MANDATORY SERVICE BULLETIN

NO. MSB-42-035

Coolant Tank Cap – Pressure Relieve Test

WI-MSB 42-035

D60-7526-30-29

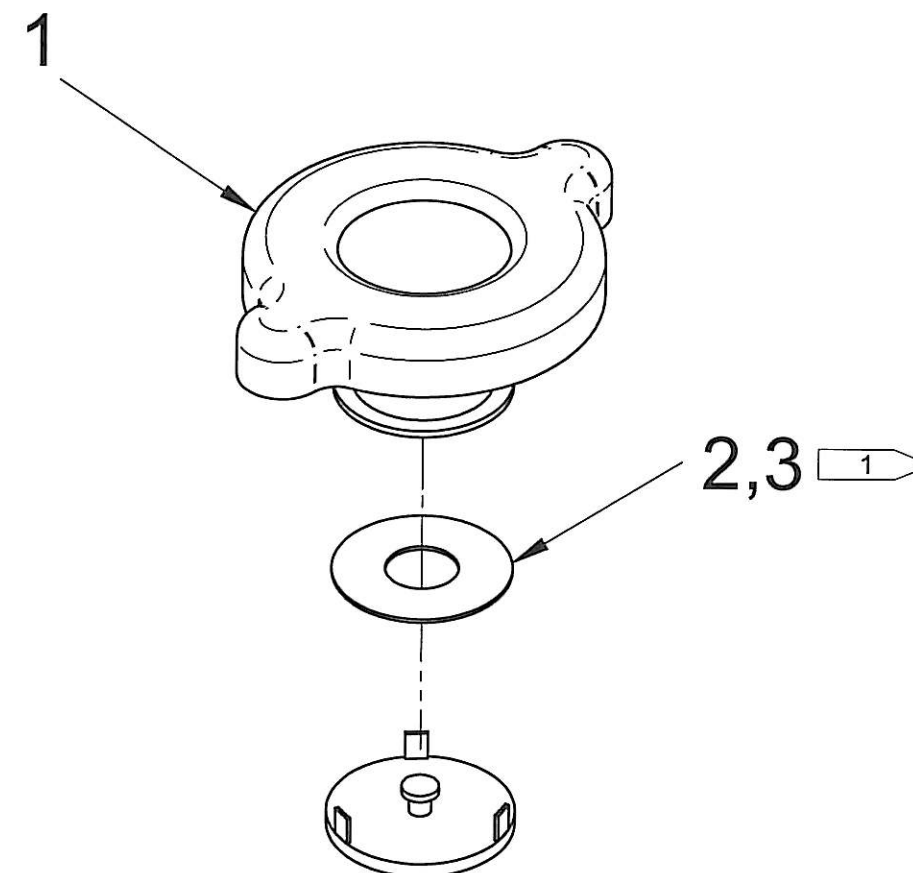
Shim washers item 2 or item 3 or any combination as required to achieve a relieve pressure of 1,8 to 2,3 bar (26.1 psi to 33.3 psi) at both cap positions.

6.	<p>If the caps relieve pressure does not meet the requirements, the cap needs to be modified in accordance with drawing D60-7526-30-29.</p> <p>Redo the checking procedure (items 4 and 5); add 1 washer each time until the requirements are met for both cap positions.</p> <p>NOTE: It is just necessary to bend one of the 3 latches to remove the lower portion of the cap.</p> <p>NOTE: Experience has shown that each latch can be bended (up and back again) 3 to 4 times. It is advised to alter the latches during the adjustment process.</p> <p>CAUTION: The bent latches must be inspected for cracks and proper fit before the cap gets released to service.</p> <div data-bbox="274 1339 1401 1937">  </div>
